SCIENCE, TECHNOLOGY AND GLOBAL SECURITY WORKING GROUP

September 4, 2012

We are following up on our letter of August 20, 2012 to provide you with additional information about some of the serious errors in the letter dated April 30, 2012 sent to your Subcommittee by the National Academy of Sciences (NAS). The letter from the NAS reports findings from a study titled *Making Sense of Ballistic Missile Defense: An Assessment of Concepts and Systems for U.S. Boost-Phase Missile Defense in Comparison to Other Alternatives*. The particular errors we are discussing herein stem from miscalculations of radar ranges that in turn lead to some, but not all, of the most serious errors in the study's findings and recommendations.

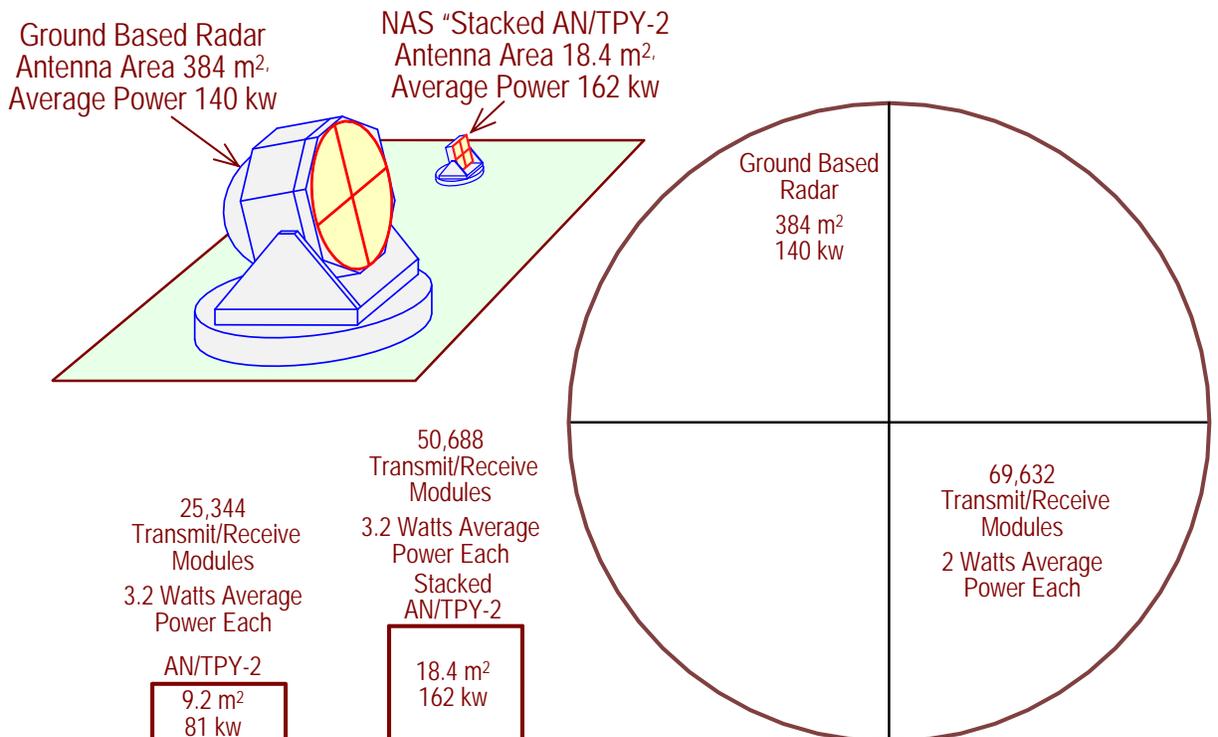
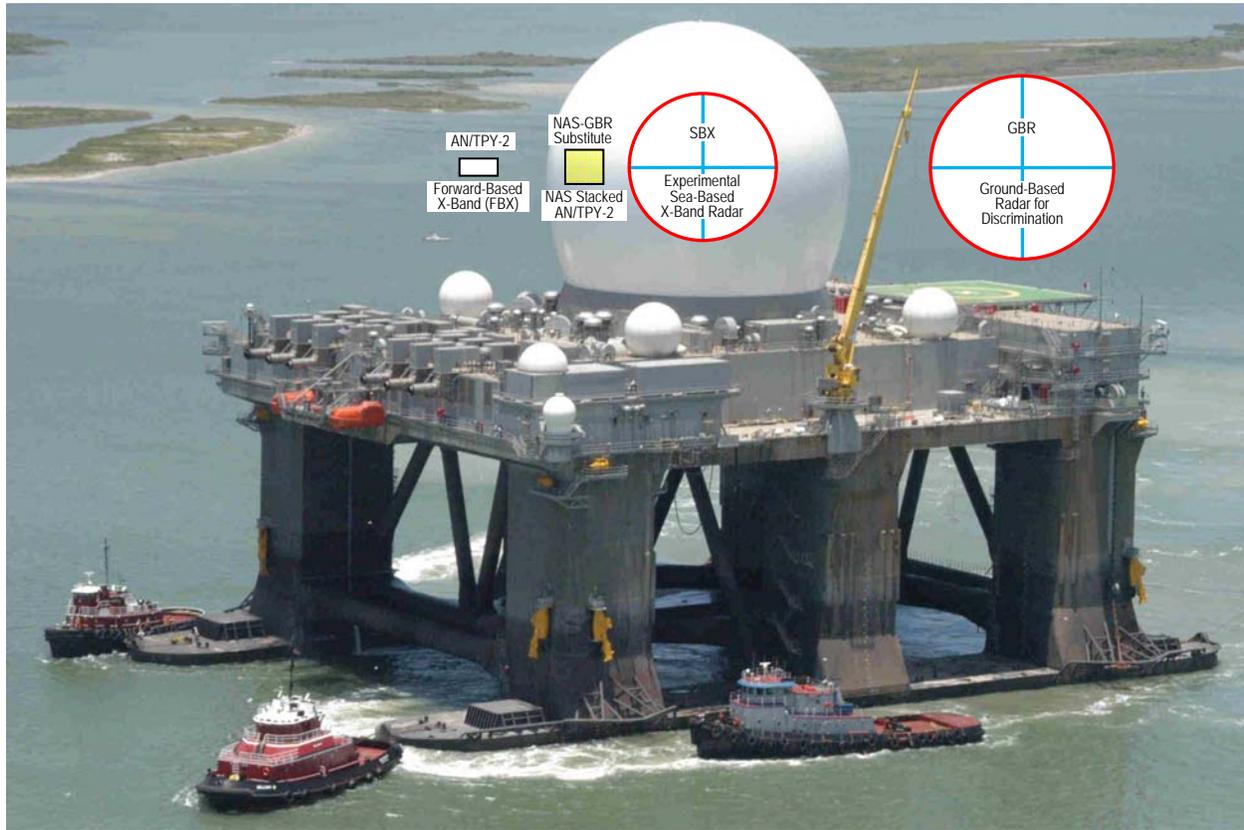
The two figures below illustrate the differences in antenna size and power of the National Academy of Sciences (NAS) "X-Band GBR Replacement" (the Stacked AN/TPY-2) with the X-Band GBR that was planned by the BMDO in 1999 for the same purpose – pairing with the Upgraded UHF Early Warning Radars. For the same operating conditions, the NAS X-Band Replacement would collect a signal roughly 400 times smaller than what would be collected by the BMDO-GBR.

In order to provide discrimination data against cone shaped warheads a radar must be able to observe distinct reflections with radar cross sections of 0.001 m² or less from the body of a warhead. The radar must also be able to observe many tens or even hundreds of targets per second. As shown in *Appendix 3B* these requirements were recognized by the Ballistic Missile Defense Organization when they proposed the BMDO-GBR for the same mission that the NAS-GBR is now being proposed for.
